Access Compliance Report

(Curb Ramps)

Intersection ID: 27432	Main Street: BALLANTYNE COMMONS PY	Cross Street: DURANT BV	Location: NW
ADA ID: 0B9432213F74	Ramp Type: Perp	Initial Pass/Fail: Pass	Overall Compliance: No
Severity Score: 10.25			
Codes/Mitigation Info/Possible Solution		Field Measurements/Component Compliance

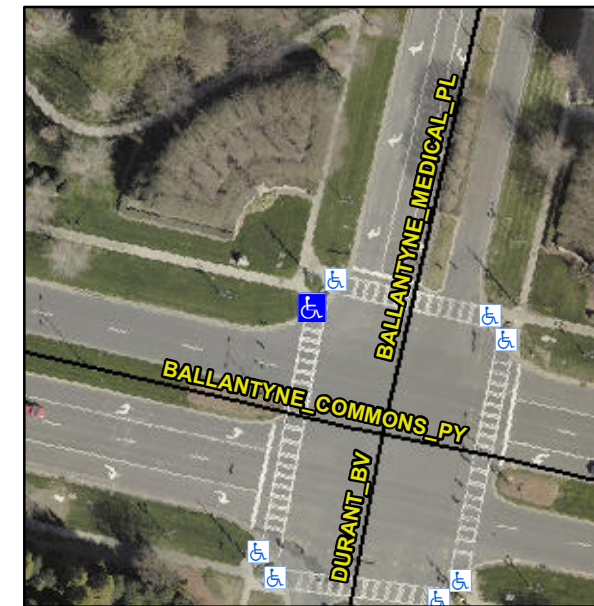
Not Found, R304.5.3, R305

Compliance	Description	Data	Compliance	Description	Data
N/A	Ramp Length (in)	134.5	Yes	Ramp Slope (%)	6.6
Yes	Ramp Width (in)	62.0	No	Ramp XSlope (%)	5.0
N/A	Flare Type LT	Sloped	N/A	Flare Type RT	N/A
N/A	Flare Slope LT (%)	2.4	Yes	Flare Slope RT (%)	8.0
N/A	Flare Traversable LT?	Yes	N/A	Flare Traversable RT?	Yes
Yes	Landing Length (in)	92.0	No	DWS Provided?	No
Yes	Landing Width (in)	62.0	N/A	DWS Contrast?	No
Yes	Landing Slope (%)	1.4	N/A	DWS Length (in)	N/A
No	Landing X Slope (%)	4.1	N/A	DWS Full Width?	No
N/A	Landing Curb? (Y/N)	No	N/A	DWS Offset (in)	N/A
N/A	Shared Landing?	No			
Yes	Gutter Ponding?	No	Yes	Gutter Slope (%)	1.6
Yes	Gutter Lip Ht (in)	0.0	Yes	Gutter X Slope (%)	2.1
N/A	Painted X Walk1?	Yes	N/A	Painted X Walk2?	N/A
	X Walk 1 Direction	To SW		X Walk 2 Direction	N/A
N/A	X Walk 1 Width (in)	125.0	N/A	X Walk 2 Width (in)	N/A
	X Walk 1 Slope (%)	0.2		X Walk 2 Slope (%)	N/A
	X Walk 1 X Slope (%)	3.6		X Walk 2 X Slope (%)	N/A

Remove & Replace Entire Ramp.
